Delegated Report

Approval of Details Application

Planning Application No: 20260475

Location: Land North of Brecon Heron Hill Lane Meopham Gravesend

SITE DEVELOPMENT SCHEME- SITE LAYOUT Scale 1:500 A4
Birchwood, Land north of Brecon, Heron Hill Lane, Culverstone
Mr LJ Mahon

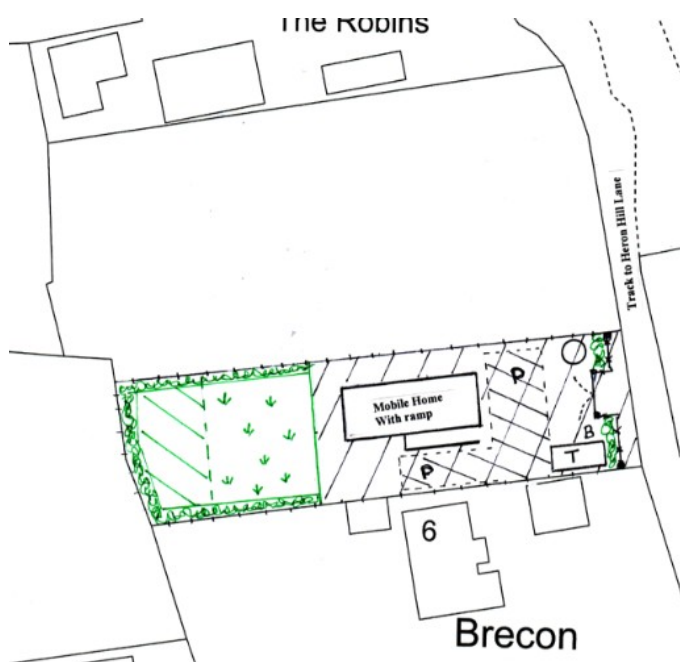
The applicant has submitted the above site plan. The site plan shows a mobile home will be located in the centre of the site, with a touring caravan to the front of the site positioned along the side boundary. There would be a grassed amenity area to the rear of the mobile home. The photo above shows the existing site which is currently grassy.

The area to which the mobile home will be sited, and where vehicle parking is to be provided will be covered in hardstanding. Over 60% of the site will be covered in hardstanding. Whilst it is noted that some hardstanding would be necessary for parking and ramped access to the mobile home, the extent of hard standing proposed is excessive and goes beyond what would reasonably be required for parking and ramped access. It is considered that a maximum of three off street car spaces will be sufficient for this site, a large parking area is proposed which would wrap around the mobile home, it is considered that there would be an excess of parking.

It is considered that the proposed layout would fail to comply with the above guidance, as the hard standing proposed would be excessive and not proportionate to the size of the dwelling and the required car parking. It is considered that the extent of hardstanding proposed would harden the appearance of the site. It is noted that the site is located within the Harvel Wooded Downs Landscape Character Area, the proposal would result in harm to the Landscape Character Area.

Whilst the access, bin storage and amenity areas proposed are considered to be acceptable, the extent of hardstanding would be excessive. As such the submitted details are considered to be unacceptable.

The submitted site plan shows that there would be a post and rail fence along the front boundary of the site, along the side and rear boundaries of the site there would be 2m tall timber fence panels. The proposed fencing along the side boundaries would be acceptable and in keeping with the type of boundary treatment used in the surrounding area.
